SUBJECT: ISSUANCE OF AMENDMENT NO. 24 TO FACILITY OPERATING LICENSE  
NO. NPF-41 FOR THE PALO VERDE NUCLEAR GENERATING STATION,  
UNIT NO. 1 (TAC NOS. 65460, 65461, 65462 AND 65691 THROUGH 65706)

PALO VERDE NUCLEAR GENERATING STATION, UNIT NO. 1

AMENDMENT TO FACILITY OPERATING LICENSE

Amendment No. 24  
License No. NPF-41

FIGURE 3.1- 1A

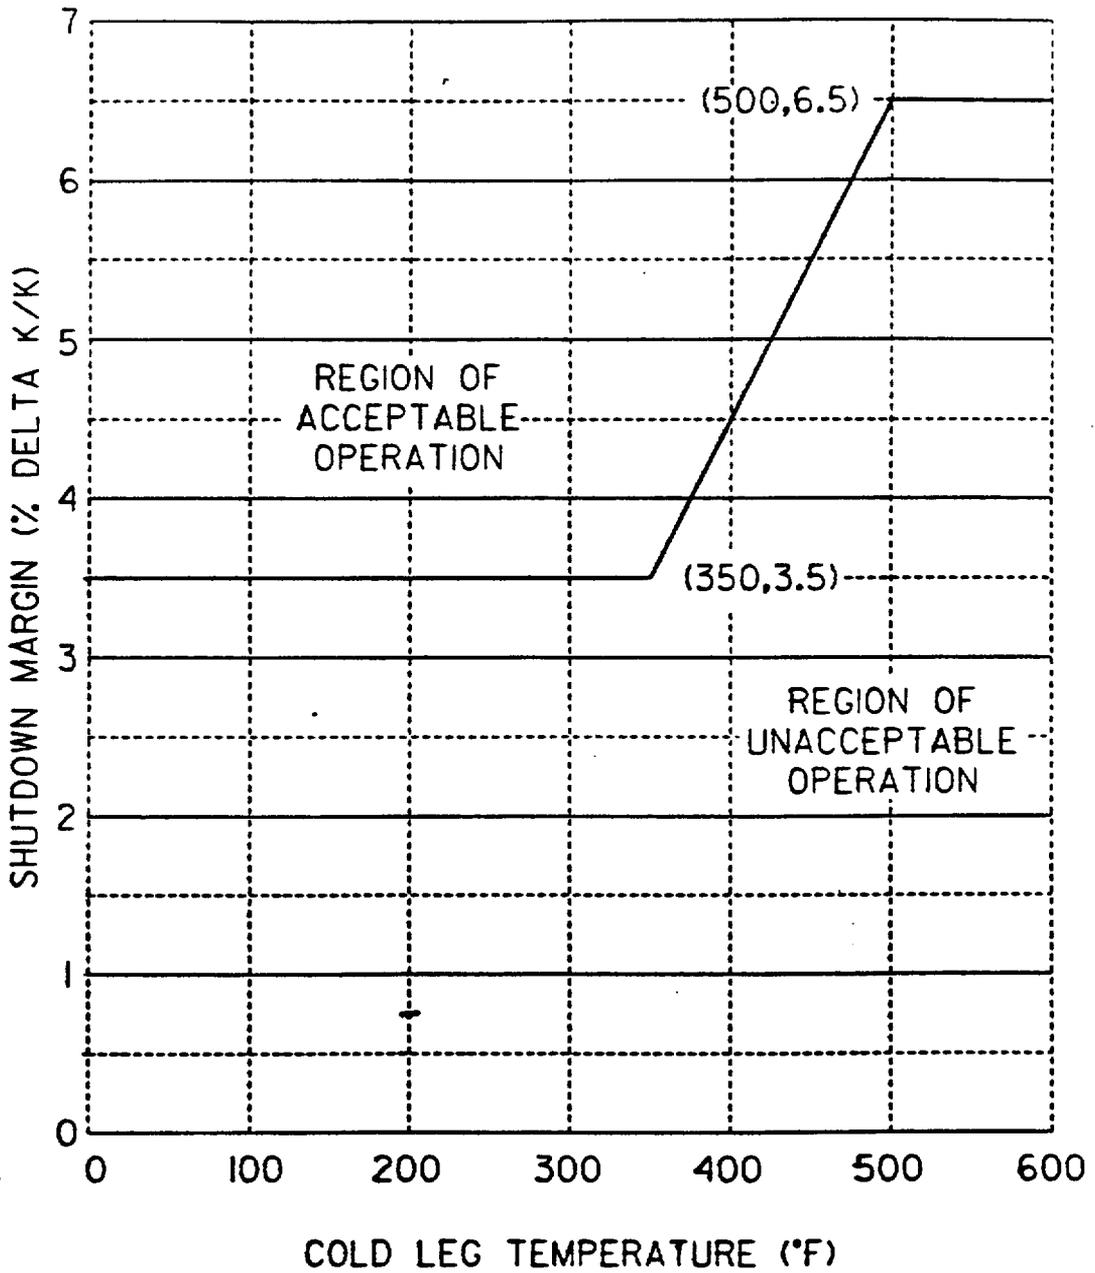
- (2) The shutdown margin versus cold leg temperature curve given in Figure 3.1-1A of Technical Specification 3.1.1.2 has been changed to increase the required shutdown margin value from 6.0% delta k/k to 6.5% delta k/k at cold leg temperatures above 500°F.

The increased shutdown margin is required to ensure that the steam-line break event at hot zero power, which is the most limiting accident with regard to shutdown margin requirements for Cycle 2, is bounded by the reference cycle (Cycle 1) analysis. Sufficient CEA trip reactivity worth is available to meet the shutdown margin requirements even with the most reactive CEA assumed stuck in the fully withdrawn position. The staff, therefore, finds this change acceptable.

FIGURE 3.1-1

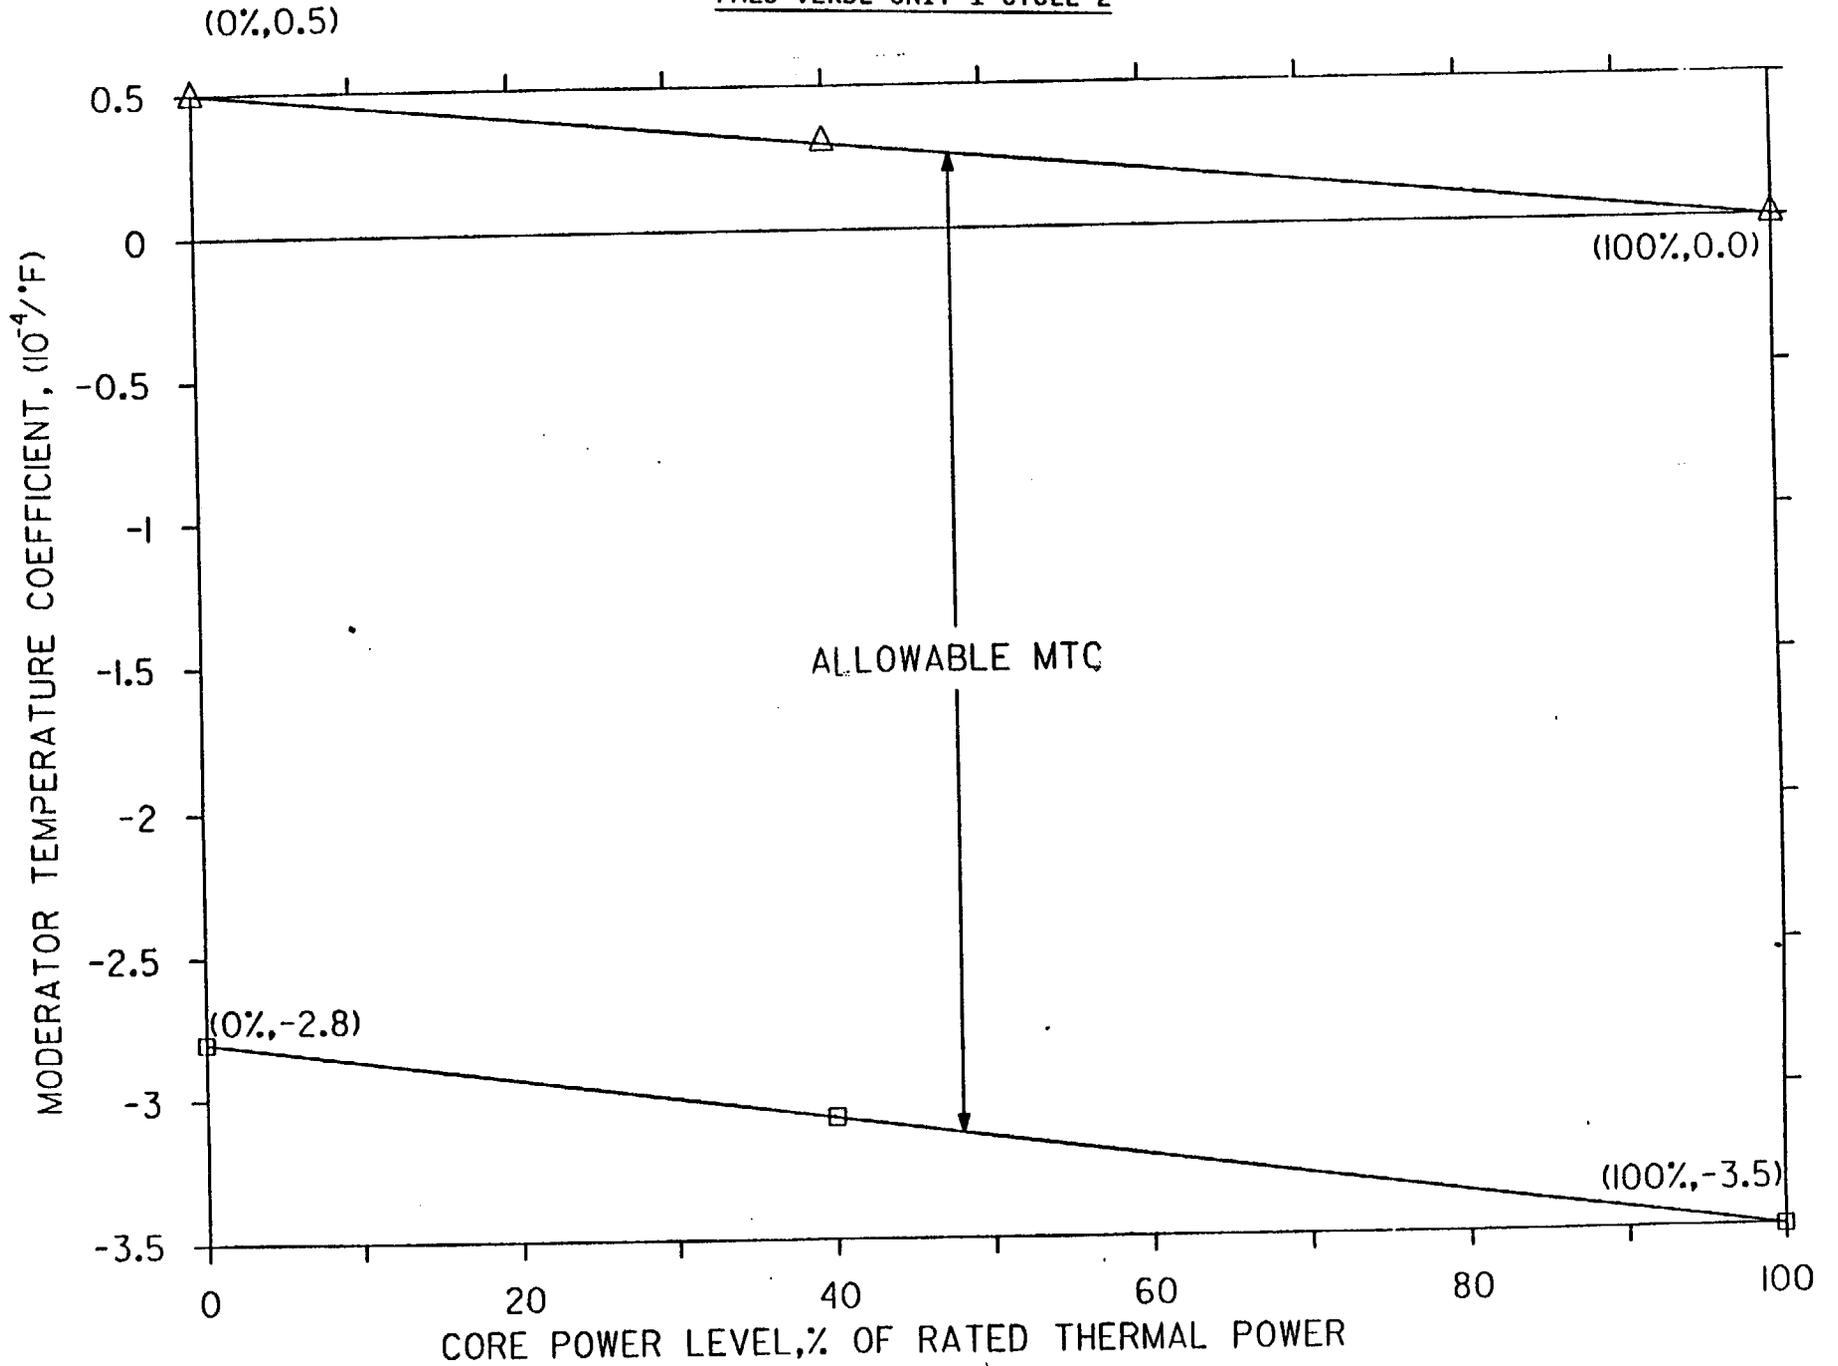
- (3) The moderator temperature coefficient (MTC) operating band, given in Figure 3.3-1 of Technical Specification 3.1.1.3, has been made more positive and the x axis has been changed to core power level instead of average moderator temperature.

FIGURE 3.1-3

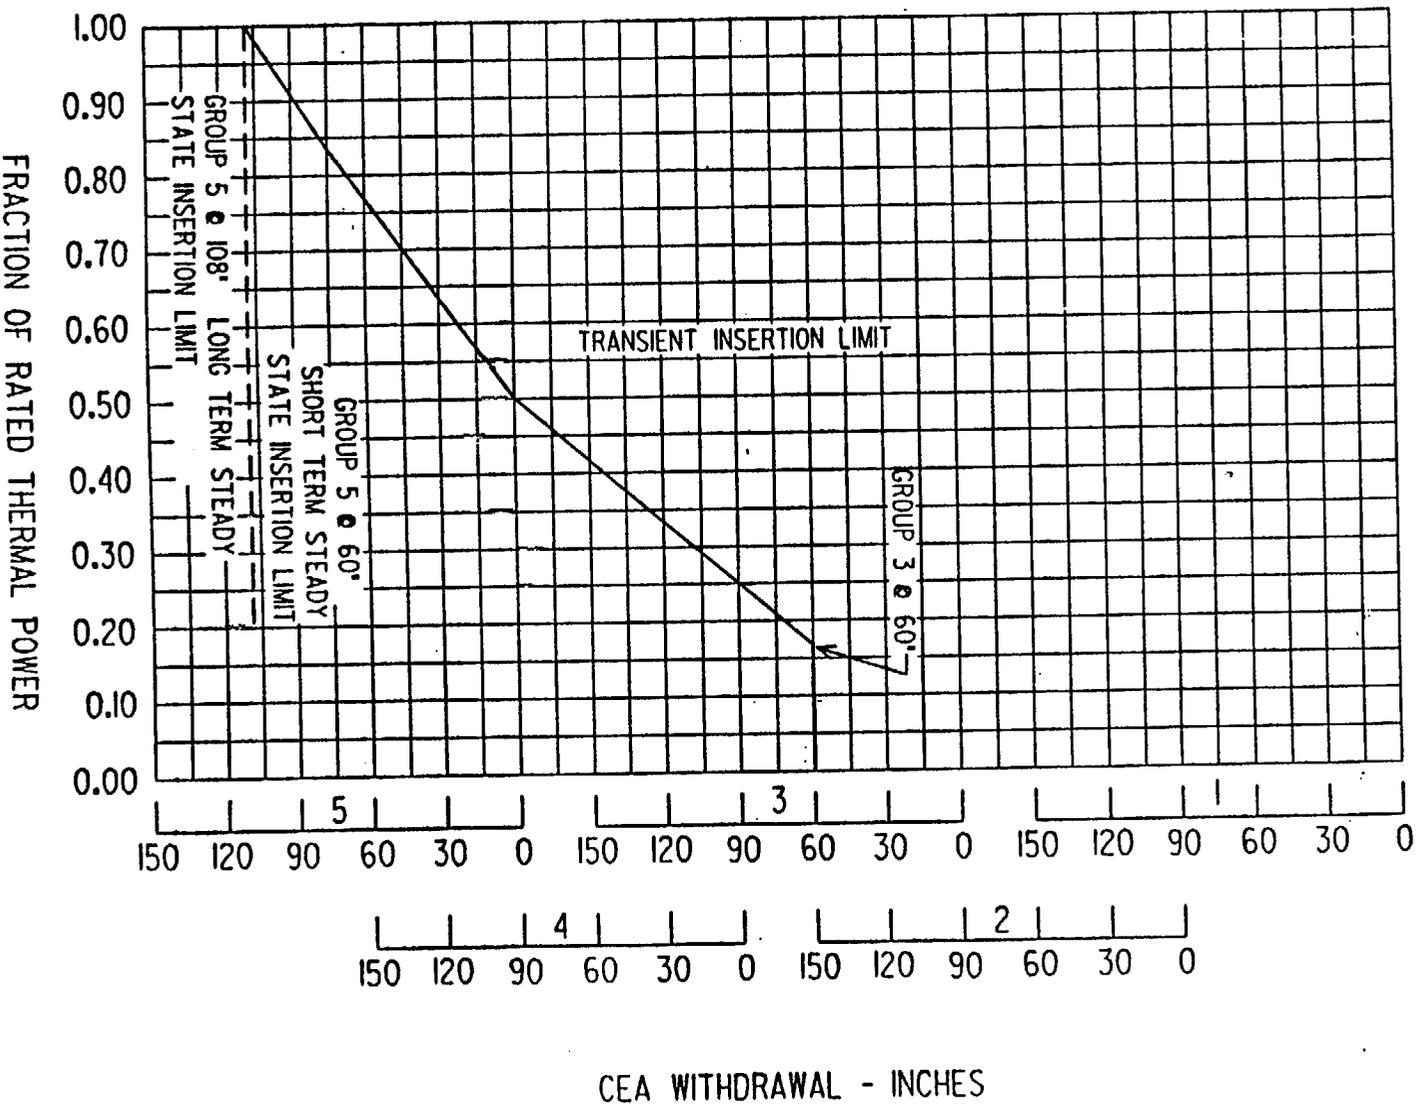
- (8) The CEA insertion limits given in Technical Specification 3.1.3.6 have been revised to account for changes in the reactivity worth of the CEAs due to the changes in Cycle 2 core.

Since the reactivity worth of the CEAs has changed, the consequences of the dropped and ejected CEA events are affected. The revised CEA insertion limits chosen, which were calculated by approved methods, ensure that there is sufficient margin to mitigate such events during Cycle 2. The CEA insertion limit revision is, therefore, acceptable.

FIGURE 3.1-5

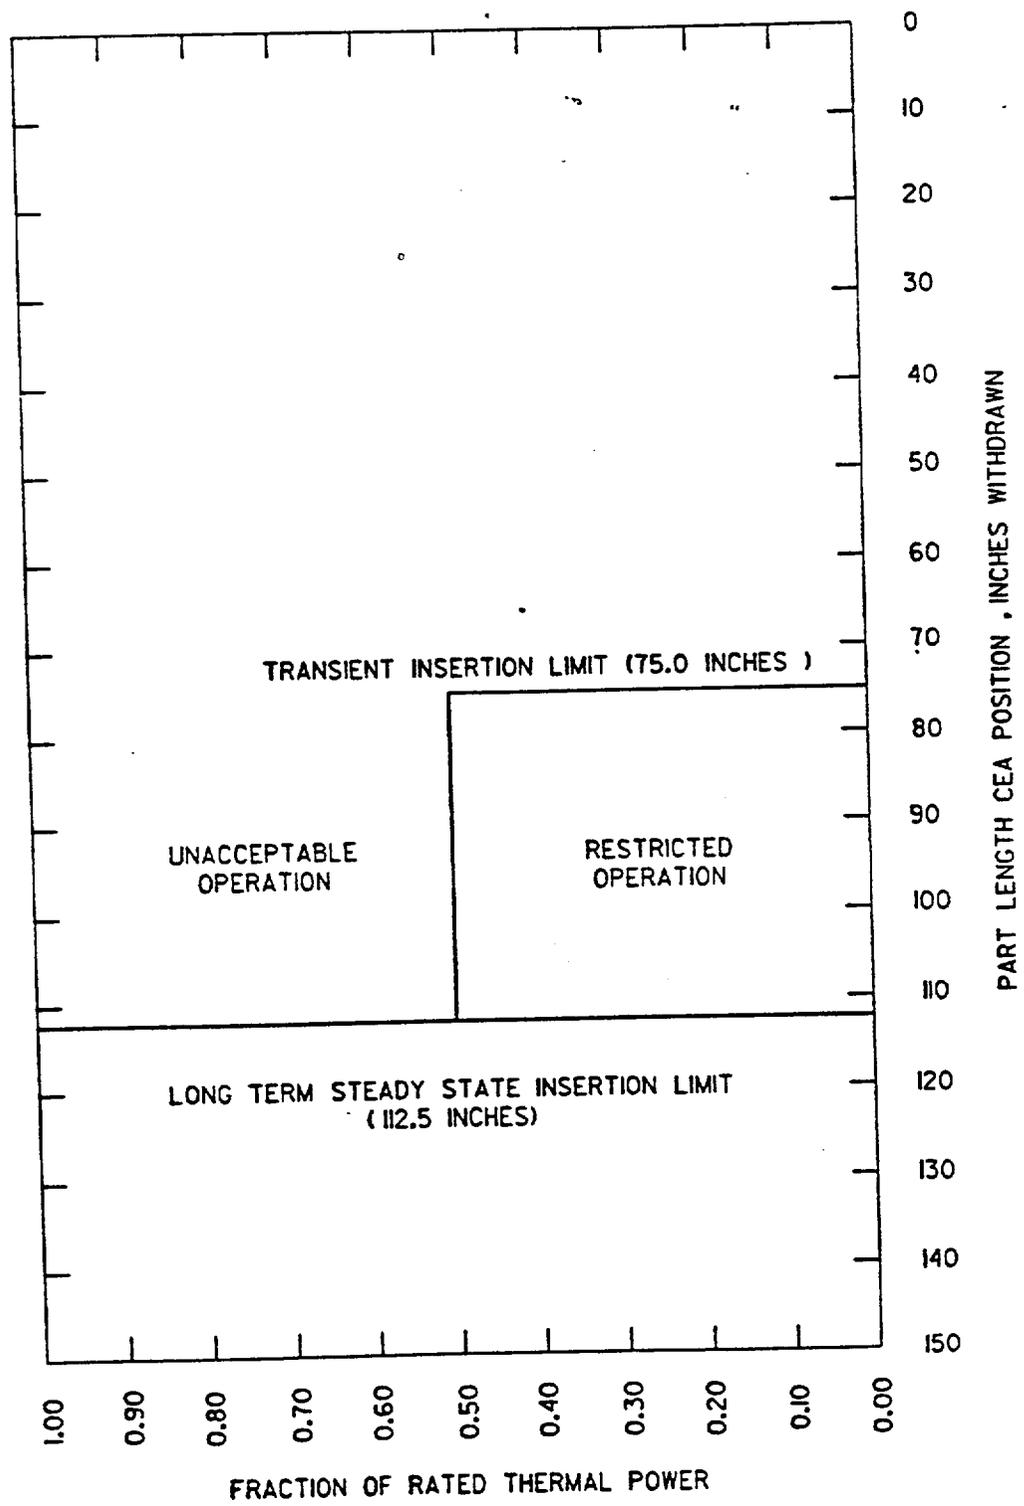
- (5) Reference to the part length CEA insertion limits have been removed from Technical Specification 3.1.3.1 and a new Specification 3.1.3.7 has been added to specify the length of time for insertion and the insertion limit of the part length CEAs specifically.

The new Specification adds a more explicit LCO to clarify the allowable duration for a part length CEA to remain within the defined ranges of axial position and reduces the potential adverse consequences of a part length CEA drop or misalignment from an allowable position. The changes are, therefore, acceptable.
